MFN 06-473 Supplement 1

Docket No. 52-010

**Subject: Response to Portion of NRC Request for Additional
Information Letter No. 79 Related to ESBWR Design
Certification Application - Containment Systems -
RAI Number 6.2-127 S01**

RAI Number 6.2-127 S01

Figure 6.2-30. Drywell Fission Product Radiation Monitoring Subsystem

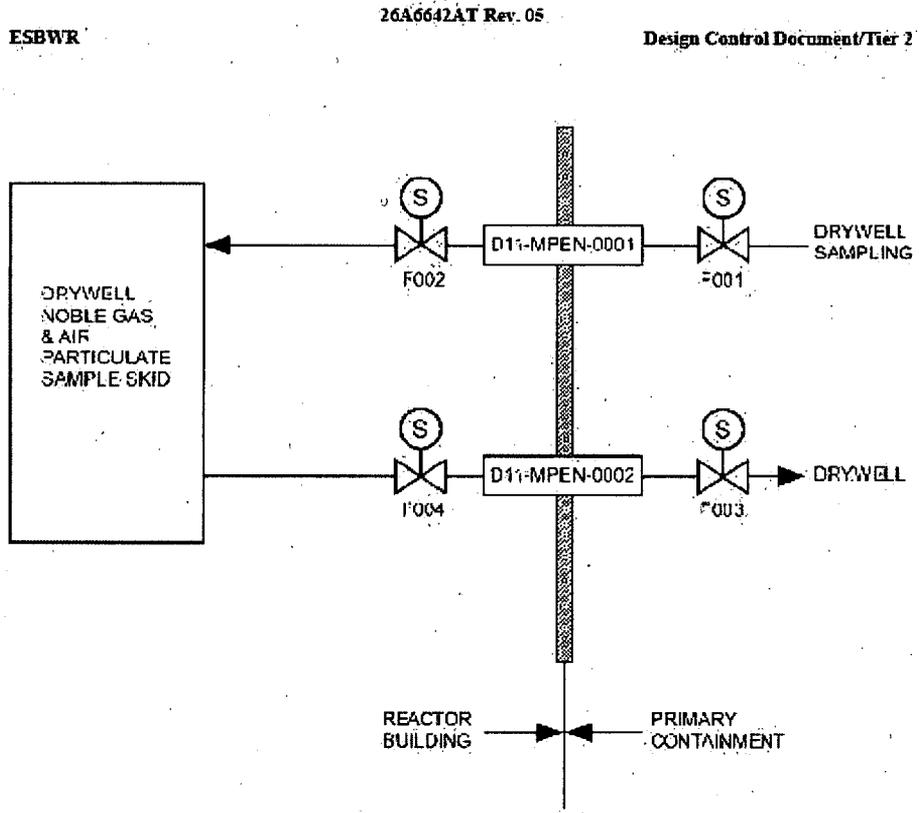
RG 1.11, section C.2, states that the lines should have one CIV inside and one outside containment (which they do not), or else conform to sections 1.b. through 1.e. The staff needs more information to determine if the lines satisfy each of these provisions, but notes, for example, that 1.c. states, in part, that the CIVs should fail as-is, whereas DCD, Tier 2, Revision 3, Table 6.2-42 states that they fail closed. Provide in the DCD a

discussion showing that these lines conform to RG 1.11, or, if not, the requirements for non-instrument lines.

The ESBWR design has been changed to include Containment Isolation Valves on the Drywell Fission Product Radiation Monitoring System (subsystem of the Process Radiation Monitoring System) incoming line, and also on the return to drywell line to comply with Regulatory Guide 1.11. These containment isolation valves will remain open all the time and shall be designed to fail in "As-is" condition. Instrument lines are discussed in DCD Tier 2, Subsection 6.2.4.2.2.

A new DCD Tier 2, Figure 6.2-30, will be added to show these isolation valves. DCD Tier 2, Tables 3.9-8 and 6.2-42, will also be revised to include both inboard and outboard containment isolation valves.

DCD Tier 2, Tables 3.9-8 and 6.2-42 will be revised, and a new DCD Tier 2, Figure 6.2-30 will be added, as shown in the attached markup.
